FAQ Log 11/17/05

TempNo.	PI	Topic	Status	Plant/ Co.
54.1	MS1-4	Exemption of overhaul hours	5/19 Introduced 7/21 Discussed 8/18 Discussed 10/19 Discussed	Catawba
55.1	MS01	Planned unavailable hours	7/21 Introduced 8/18 Awaiting licensee revision 10/19 Revised by Licensee to reflect comments 10/19 Discussed	TM11

Browns Ferry Unit 1/Unit 2 safety-related 4160 electrical distribution single line

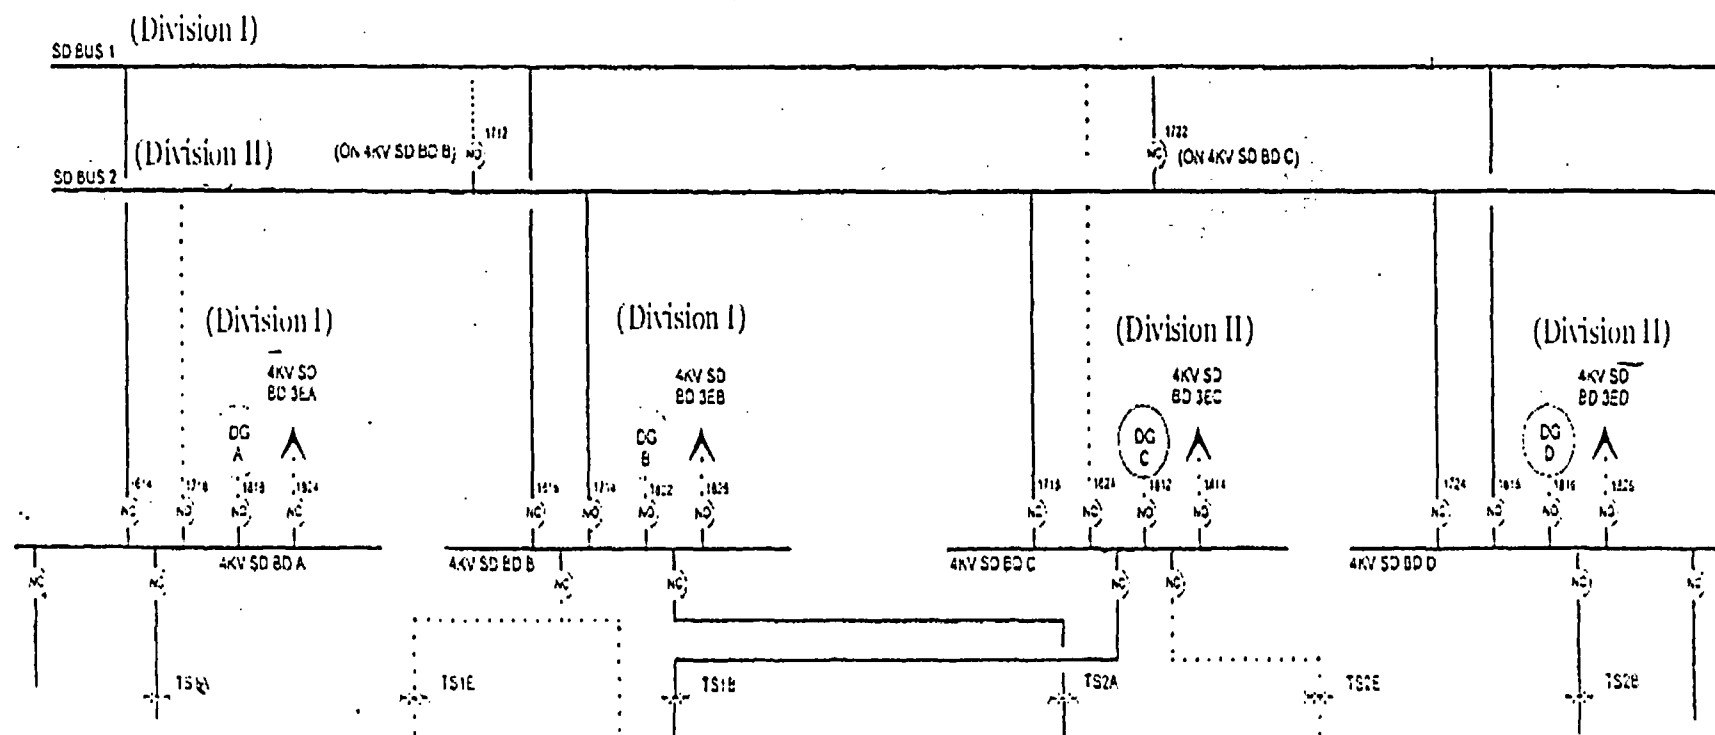
Browns Ferry Unit 1 is being recovered from an extended shutdown. Recovery efforts include replacement of cables to the Division I and Division II Emergency AC (EAC) power. The cables are being replaced in order to provide qualified cables (including requisite documentation) to meet current Environmental Qualification, Post Accident Monitoring, Voltage Drop/Ampacity/Short Circuit requirements, Appendix R, Electrical Separation and to address breakage as identified by electrical calculations.

The Division I and Division II EAC for Units 1 and 2 each contain 2 Emergency Diesel Generators and 2 4160v Shutdown Boards with each Emergency Diesel Generator and Shutdown Board supplying approximately 50% of the emergency power required for each Division EAC. The Emergency Diesel Generators and Shutdown Board are paired as A & B in Division I and C & D in Division II.

To replace these cables, Emergency Diesel Generators A, B, and D and 4160v Shutdown Boards A, B and D will be removed from service one train at a time. The work is planned such that when

A Emergency Diesel Generator and 4160v Shutdown Board A are out of service, the B, C, and D Emergency Diesel Generators and B, C, and D 4160v Shutdown Boards will remain available. Also when the B or D train is out of service the other three trains will remain available. The work to replace the cables on any one of the trains can be done within the Tech Spec AOT of 14 days for the Emergency Diesel Generator.

The effect of the Browns Ferry Nuclear (BFN) Unit 1 Emergency AC (EAC) power restoration activities on Unit 2 and Unit 3 system unavailabilities is a unique condition that had not been anticipated during the development of the PI guidance document. The unavailability of the Unit 2 and Unit 3 systems due to the Unit 1 EAC restoration work does not truly reflect the performance of the Unit 2 and Unit 3 systems. For this unique, one-time-only activity, the planned BFN Unit 1 EAC restoration may be treated similar to "Planned Overhaul Maintenance." That is, if additional time is needed beyond the original schedule duration to repair equipment problems discovered during the restoration activities, the additional hours would count toward the indicator. In addition, other activities may be performed with the restoration activity as long as the outage duration is bounded by the restoration activities. If the restoration activities are complete, and the outage continues due to non-restoration activities, the additional hours would count toward the indicator.
